37/03-04C 7312 Willow Ave
Takoma Park Historic District

SUBJECT: Historic Area Work Permit # 330444

PROPOSAL: Landscape alterations and non-original window replcaement

REVISION TO ELEVATION

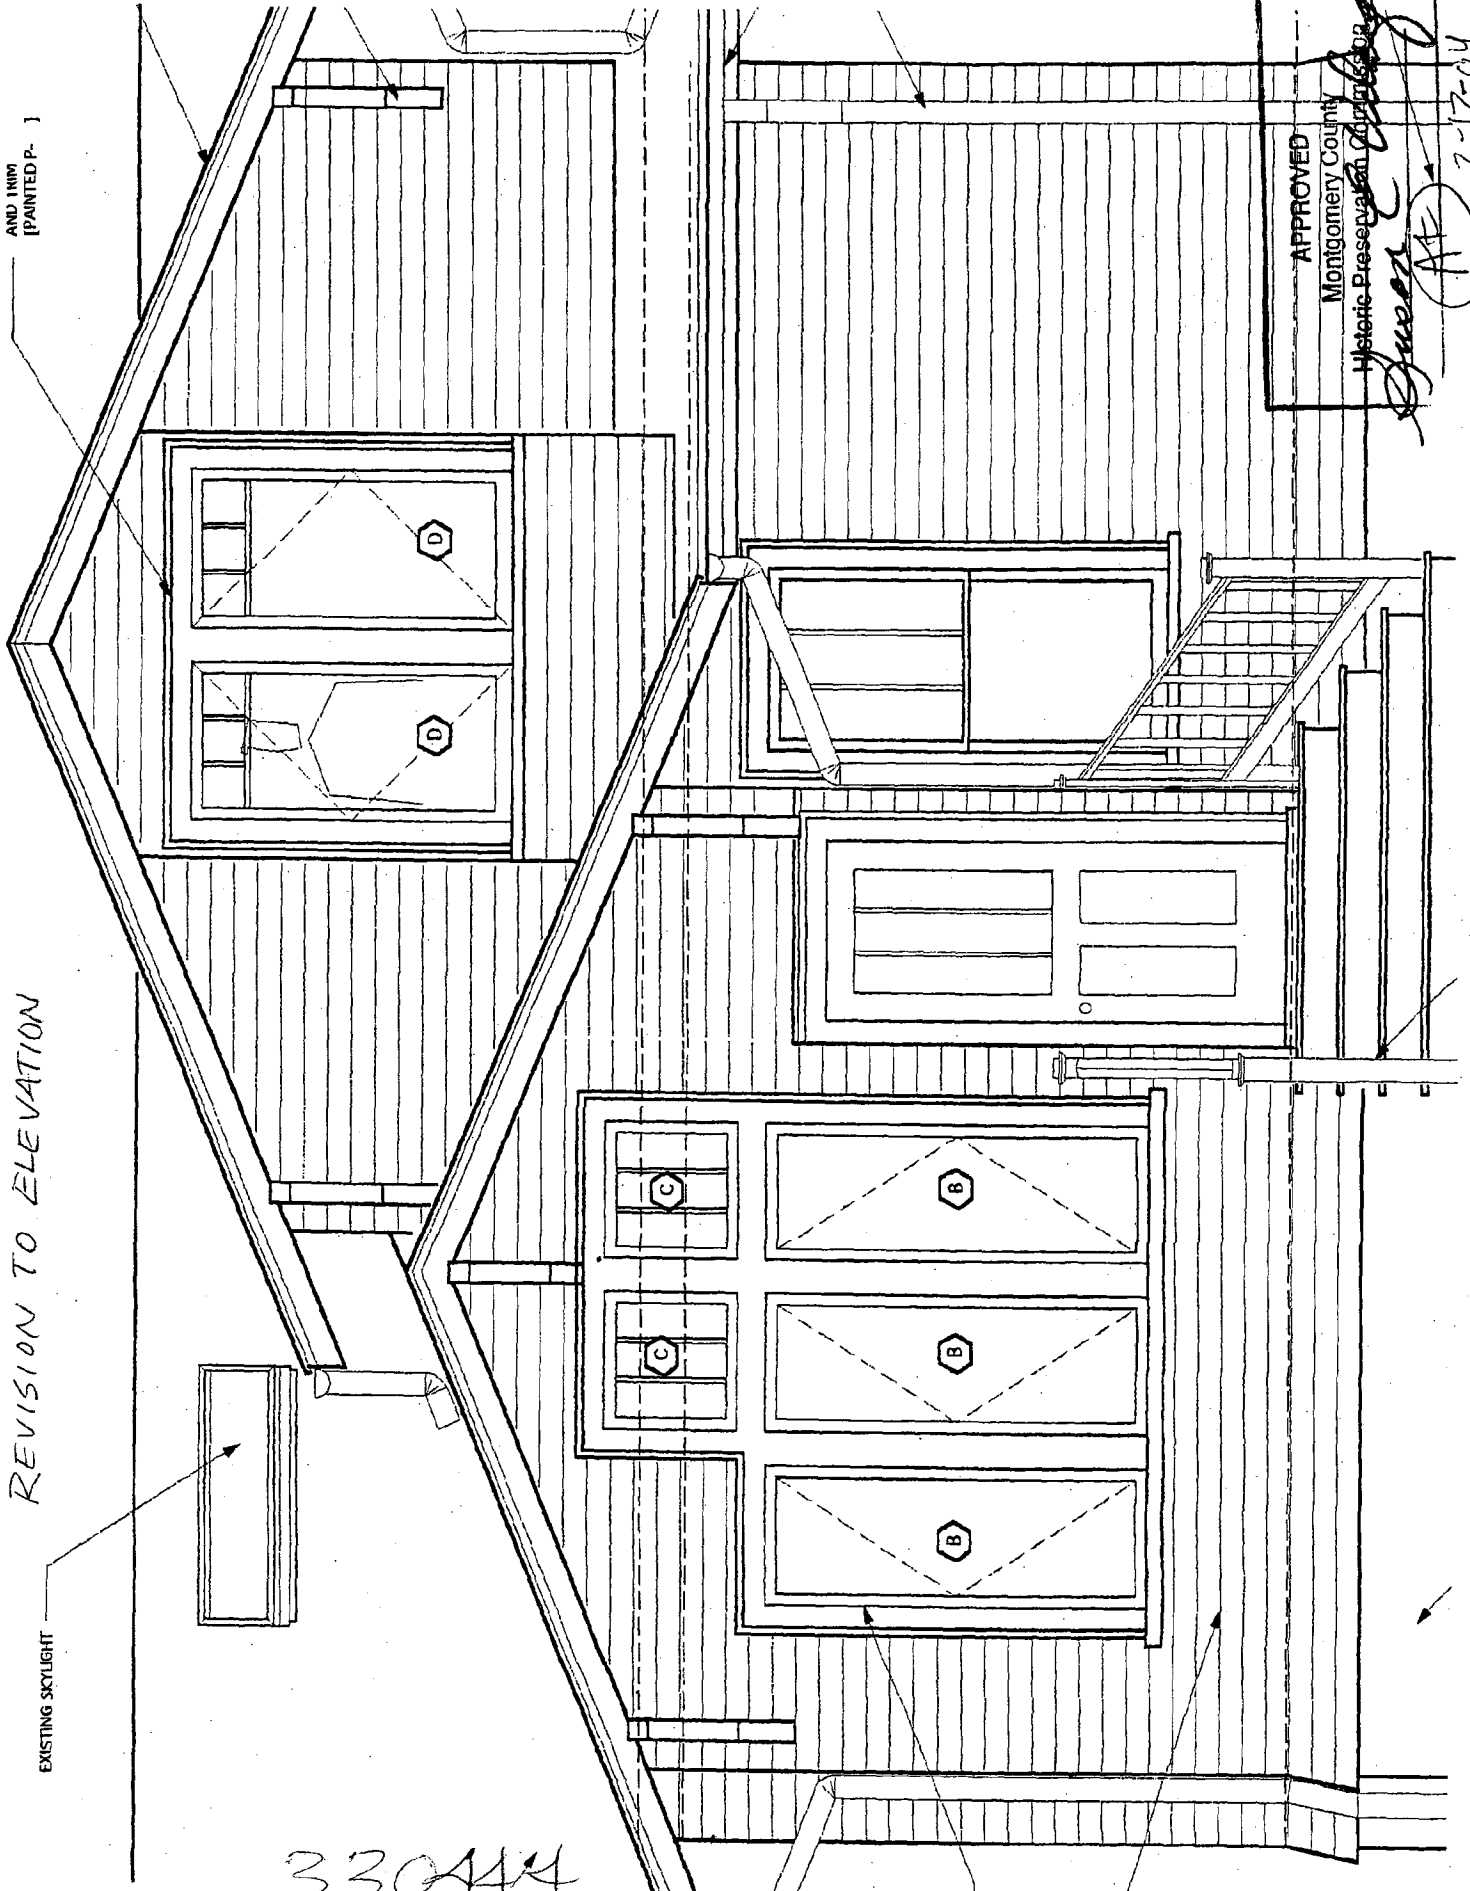
As for the design of the replacement windows, we plan to specify a custom designed sash with three-lites at the top of the sash. (See Revision to Elevation.) While the new design will not feature the verticality of the lites in the original design, the use of three-lites is in the spirit of the original window design.

INSPECTION DISAPPROVAL

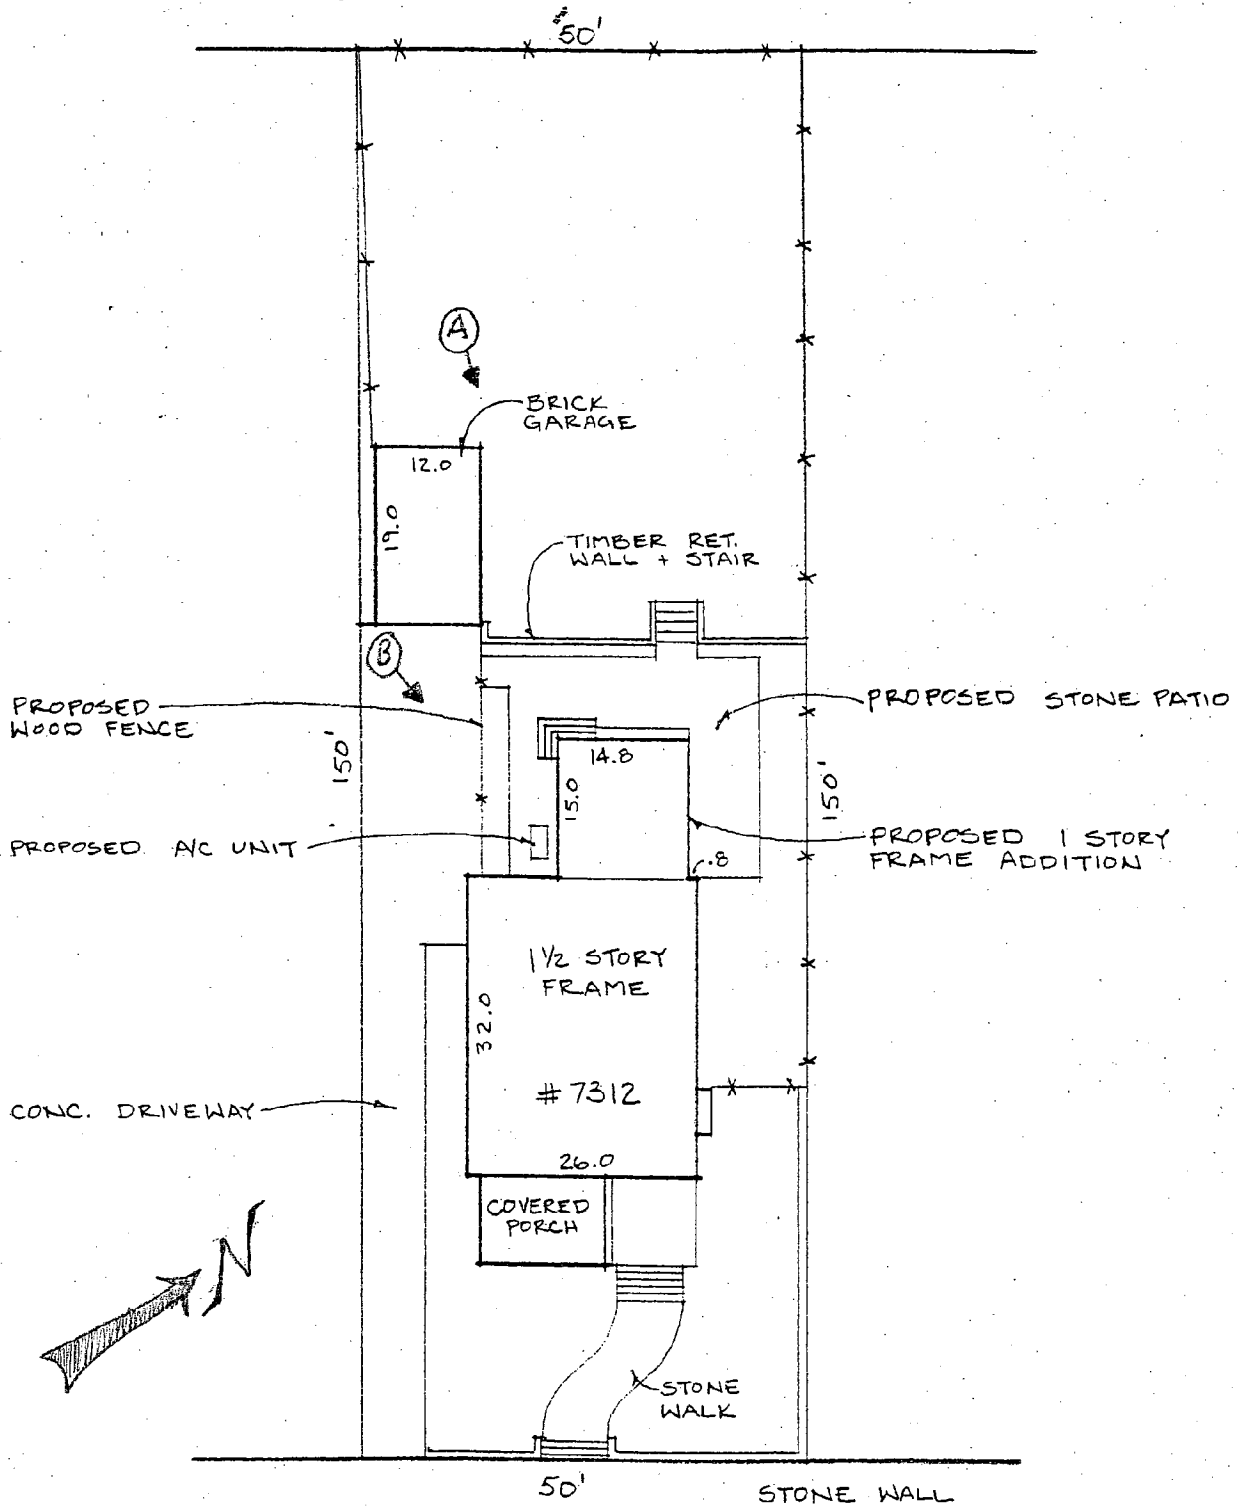
Type of Inspection Final		Permit Number
Name of Inspector Mauman	Telephone Number 3703674	Date 12-8-03
Reason for Disapproval	Code	
<input type="checkbox"/> Incomplete Installation	Section(s)	All glazing within 34" Arc of operable door and within 60" of floor must be safety glazed.
<input type="checkbox"/> Code Violation

Deficiencies
 ② Bedroom must have at least one egress window that is at least 5.7 sq-ft clear opening. Min. clear height 24" min. clear width 20". Must be normal operation of window (tilt sash does not give any bonus)
 Must complete within 30 days. No later than Jan 10, 2004

PROJECT 1
 7312 WILLOW AVENUE - SITE PLAN
 SCALE: 1" = 20'

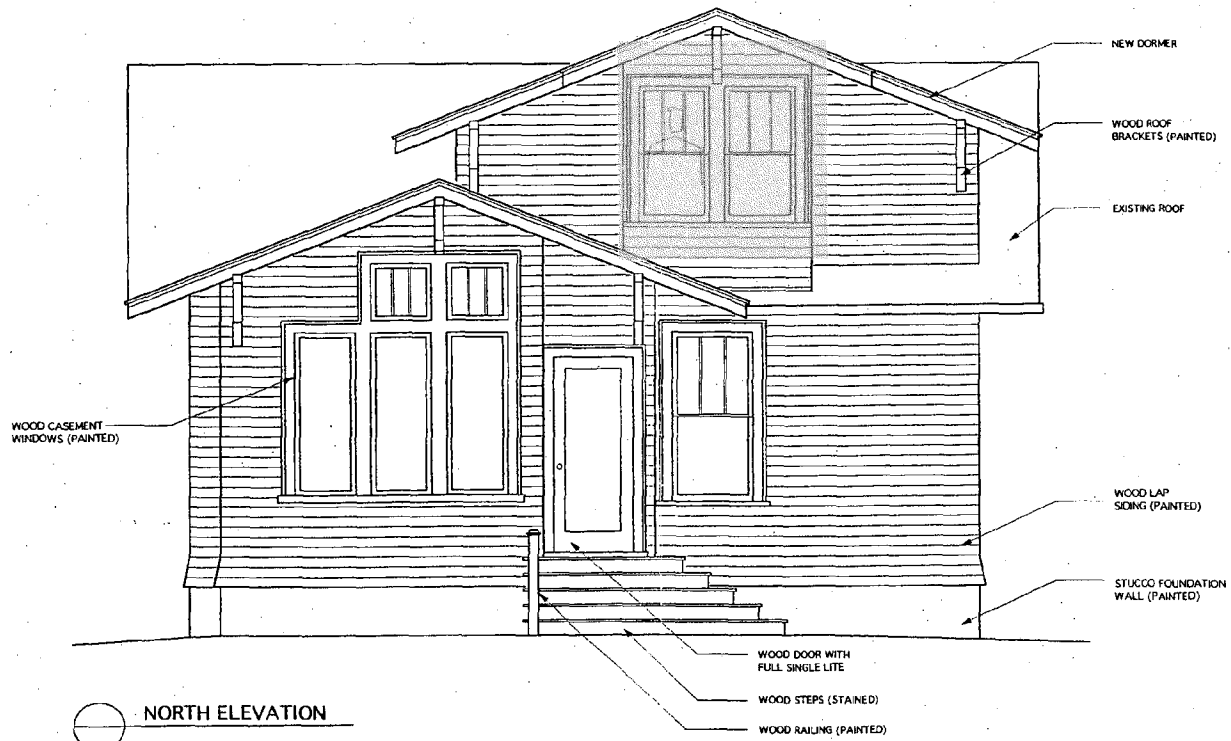
For clarification, although the "Project 1 Site Plan" in Circle 8 shows a proposed wood fence and A/C unit in the back of the house, this was the site plan from the original 1999 application and those features were already approved by the HPC as part of the previous HAWP and are not a part of this HAWP application.

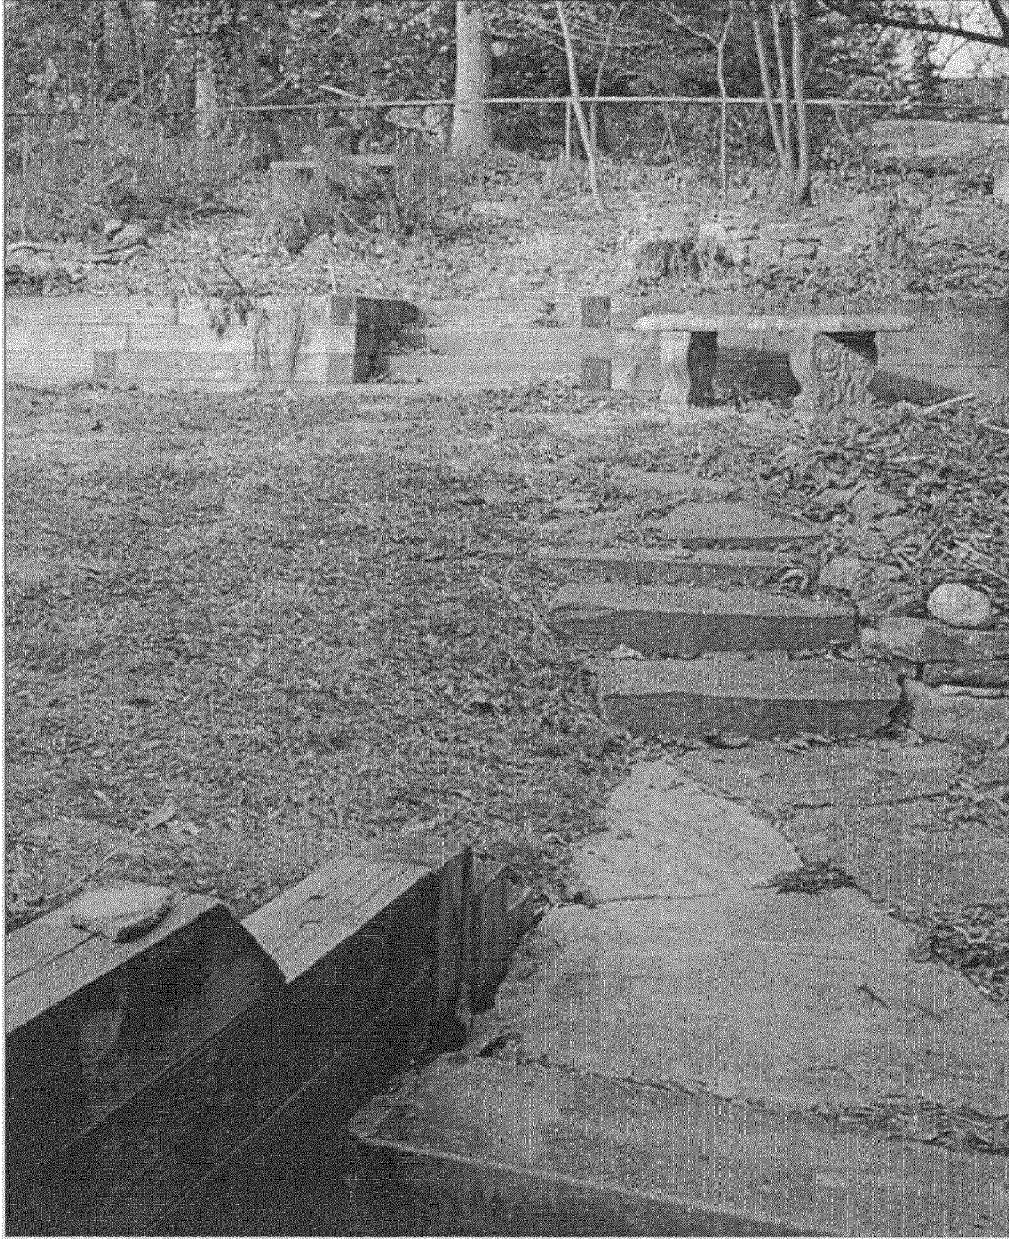
They also are proposing to make the following landscape improvements at the rear of the house (see "Project 2 Site Plan" in Circle 15):

- Remove the non-original fireplace and cinder block box
- Replace the loose rock wall with a 24" tall, 40' long dry stack Carderock stone retaining wall

- Relocate the flagstone walkway
- Install a 3-4' diameter round flagstone platform

The landscape improvements would not be visible from a public right-of-way and would not adversely impact the character of the house, district, or streetscape. The proposed materials are compatible with the house and setting and staff recommends approval of these alterations.
